Technical Service Bulletin: tsb080089

Alternator Issues in Arctic Conditions

13400153

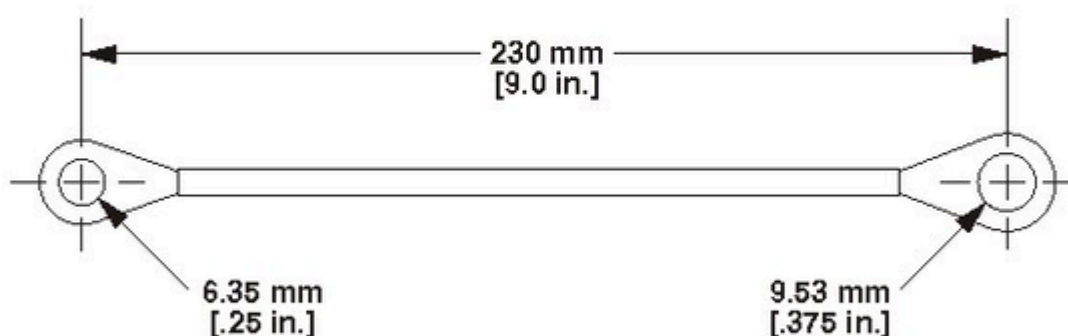
When upgrading to the Prestolite alternator, the ground wire will have to be changed as the Prestolite BLD 3314GH has a higher output than the Delco-Remy™ 33SI. The ground wire is presently **not** available for purchase from Cummins Inc.

The specification for the ground wire is:

2 AWG

230 mm [9 in] long

One eyelet with an internal diameter of 6.35 mm [1/4 in]

One eyelet with an internal diameter of 9.53 mm [3/8 in]

Photographs of an installed Prestolite BLD 3314GH alternator.

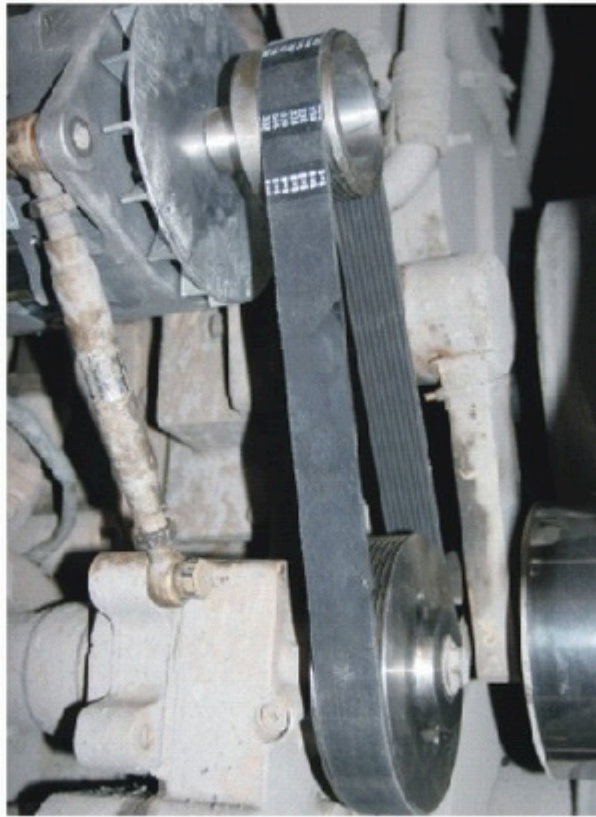
Replace failed Delco-Remy™ 33SI alternators with the Prestolite BLD 3314GH alternator, as the Prestolite alternator is more capable of coping with extreme arctic temperatures of -40°C [-40°F].

All 19L engines built after November 2008 for arctic applications now include the Prestolite BLD 3314GH alternator and the required change of pulleys, belt, and ground wire.

There are no changes to the mounting bracket, tensioning arm, or the installation/removal and belt tension procedures, and no service tools required.
